REV	DATE	BY	DETAIL
A	13.06.18	GH	ROOF DESIGN-FACADE AMENDMENTS
B	30.01.19	GH	AMENDMENTS LISTED

P L A N N I N G

PROJECT TITLE
 3 FITZROY CLOSE, LONDON, CAMDEN, N6 6JT.
 DRAWING TITLE
 PROPOSED FRONT AND SIDE ELEVATION
 CLIENT
 MR M CLACK & MS L FRY
 PROJECT NO.
 P17-025
 DRAWING NO.
 02-05-001-B
 DRAWN BY
 GH
 DATE
 04.04.2018
 SCALE
 A1@1:50

1.FRONT ELEVATION

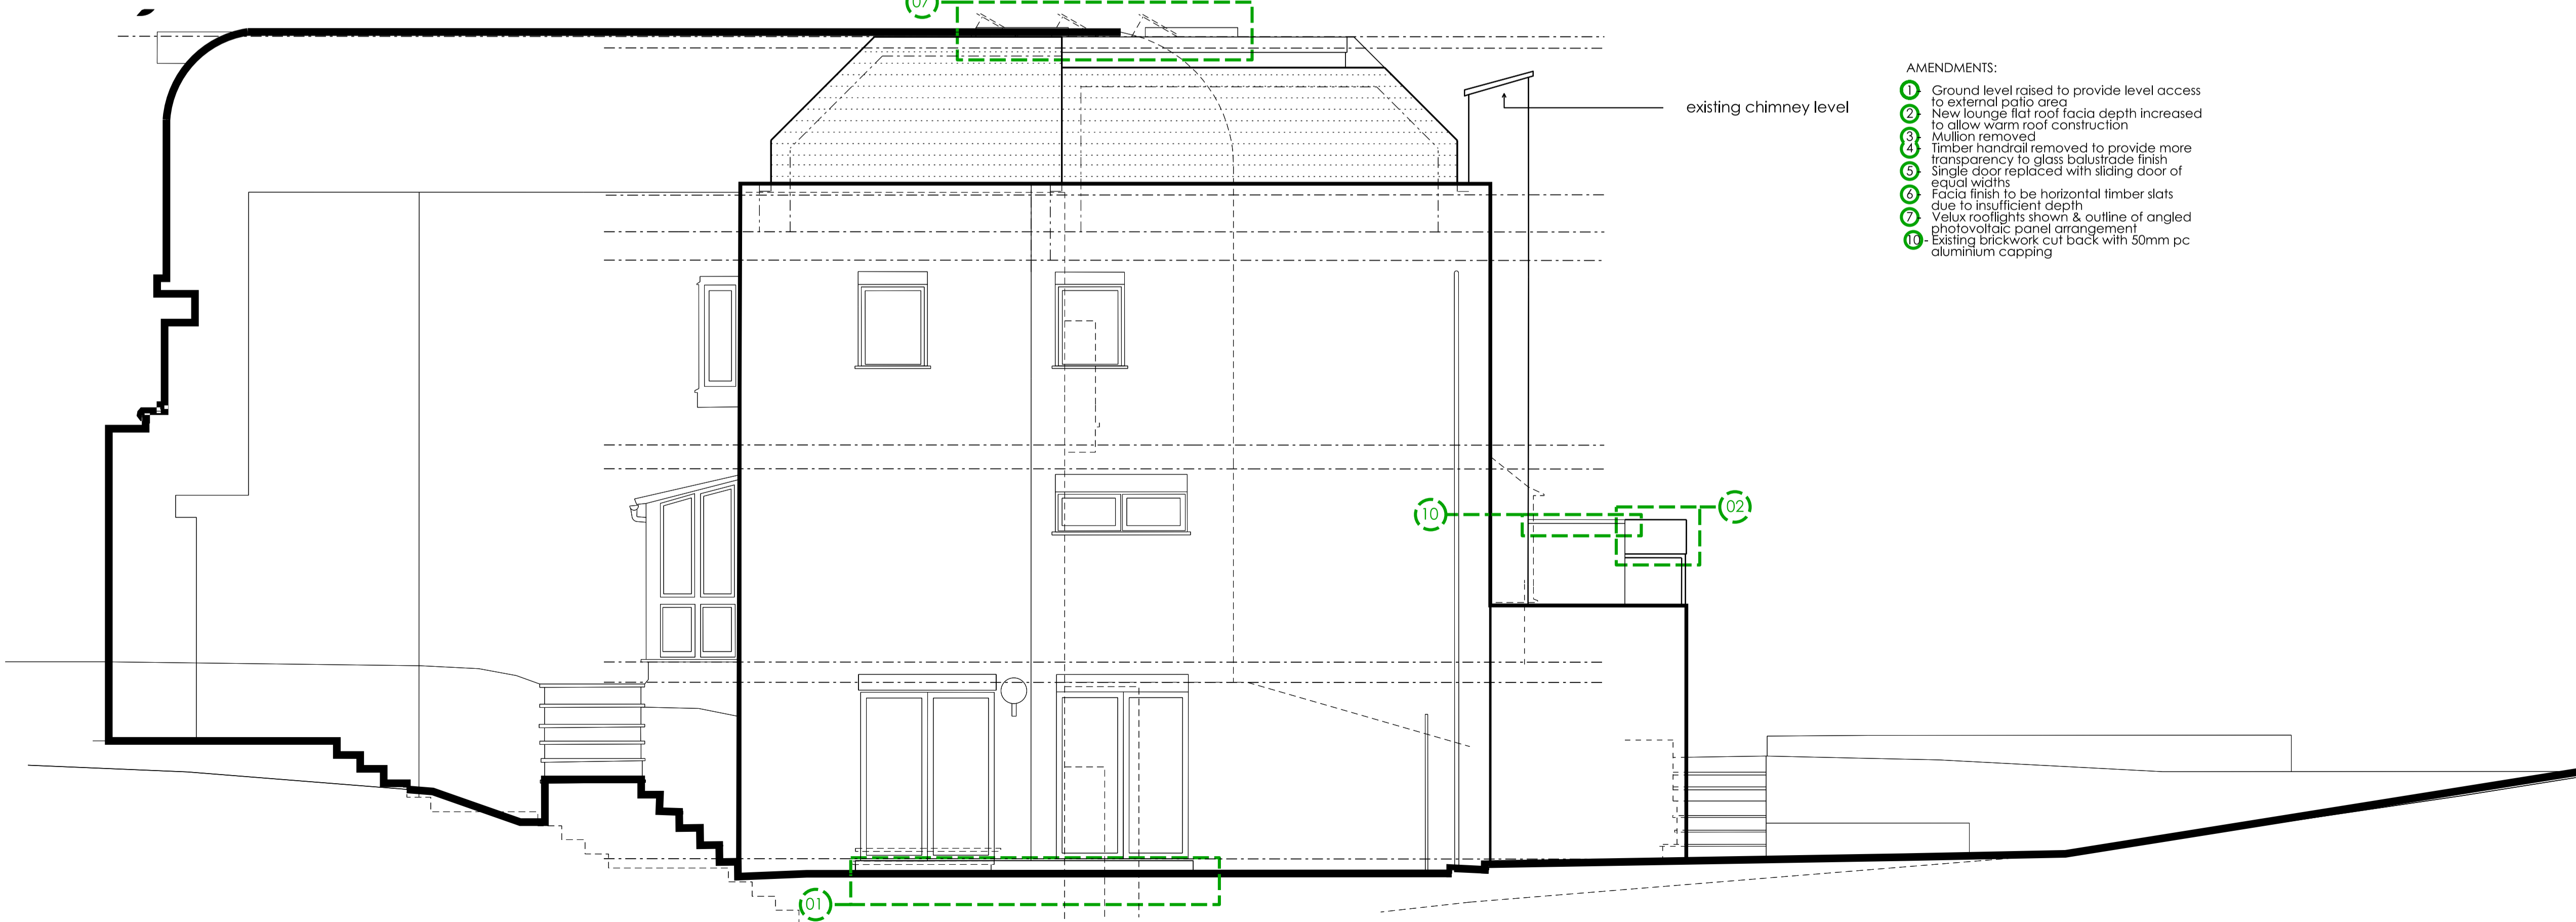
- AMENDMENTS:
- ① Ground level raised to provide level access to external patio area
 - ② New lounge flat roof fascia depth increased to allow warm roof construction
 - ③ Mullion removed
 - ④ Timber handrail removed to provide more transparency to glass balustrade finish
 - ⑤ Single door replaced with sliding door of equal widths
 - ⑥ Facia finish to be horizontal timber slats due to insufficient depth
 - ⑦ Velux rooflights shown & outline of angled photovoltaic panel arrangement
 - ⑩ Existing brickwork cut back with 50mm pc aluminium capping
